Delegated Report	Analysis sheet	Expiry Date:	25/01/2022
	N/A	Consultation Expiry Date:	30/01/2022
Officer		Application Number(s)	
Josh Lawlor		2021/3191/P	
Application Address		Drawing Numbers	
31 Crediton Hill London NW6 1HS		See decision Notice	
Proposal(s)			
Enlarged driveway and hardstanding in front garden and associated widened dropped kerb as an amendment to planning permission 2019/0810/P dated 10.5.19 (for Alterations to the front driveway, front steps to property and front garden) (part-retrospective).			
Recommendation(s):	Refuse Planning Permission		
Application Type:	Full Planning Permission

Figure 1. Pre-existing front drive

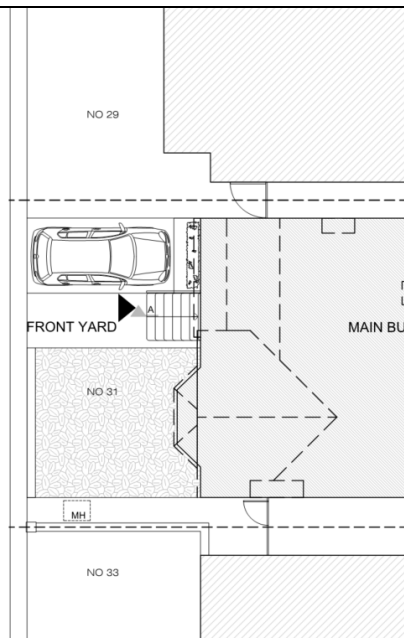
- 3.3. The pre-existing green front garden contributed to the character and setting of the host building and provided an attractive visual interest to the street scene. The vegetation provided a soft and natural setting to the architecture behind. The pre-existing front garden is considered to contribute to the verdant character of the street.

Figure 2. As approved (left) and as built drive with proposed changes to crossover (right)

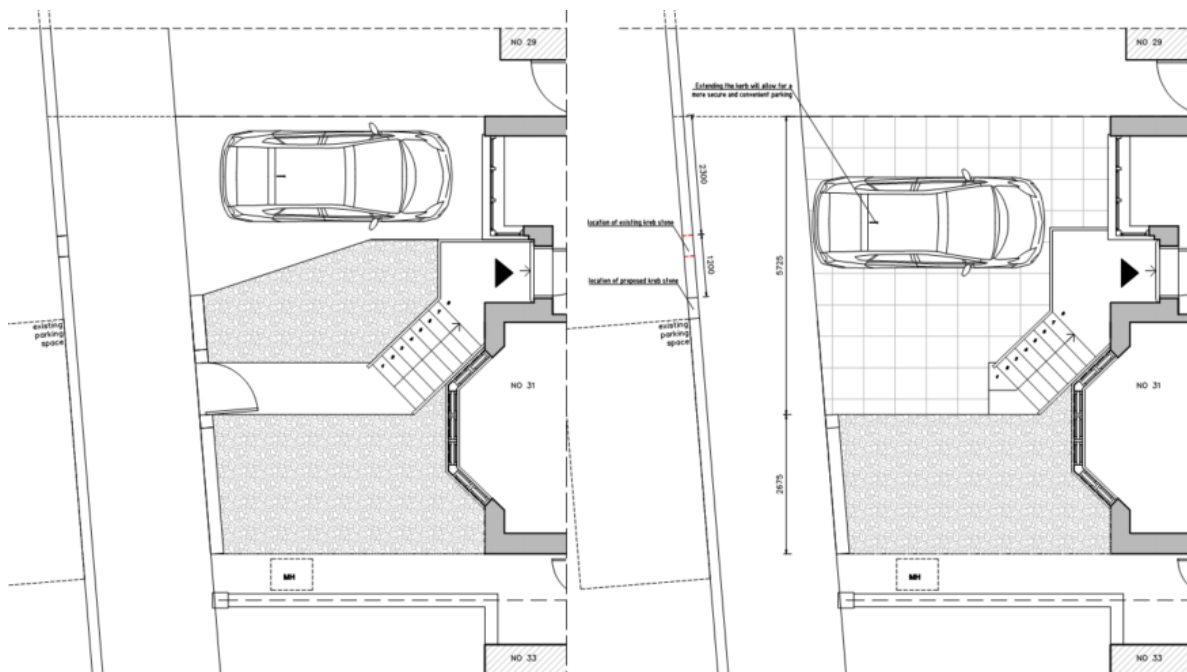
1.1. Planning permission is sought to make changes to the front drive and garden, which has been mostly implemented now (retrospective). Planning permission was granted under ref. 2019/0810/P dated 10/05/2019 for minor alterations to the front drive. The development was not carried out in accordance with the approved drawings as the extent of the hardstanding has been increased, a larger section of the low-rise brick has been demolished than was consented, and the stair and platform extends further into the driveway. Figure 1 shows the pre-existing layout and Figure 2 shows the approved and proposed layout and location of the stair. The proposal includes widening the dropped kerb by 120mm, which has not been carried out yet.

- 3.4. Officers sought to retain a larger area of soft landscaping in the scheme granted planning permission Ref. 2019/0810/P dated 10/05/2019. This application was amended as a result in order to minimise the loss of soft landscaping. The approved scheme retained rather more than half coverage with greenery to the front garden, maintaining the leafy character of the conservation area. The as-built scheme is approximately two thirds hardstanding. This multiplies the effect of the inappropriate bright white stone that has been used as a surface. In addition, a section of the boundary wall and entrance gate that had been shown as separating the footpath from the drive have been omitted, meaning that the character of the garden has changed. The spatial definition between the front garden/area of hardstanding and the street has been lost. It has changed from a more or less traditional front garden containing a parking space to an uncharacteristic and incongruous Mediterranean-style yard, with what amounts to little more than

- 3.5. The stair has been extended further than consented as the platform projects further across. This means that it appears more dominant and out of character.
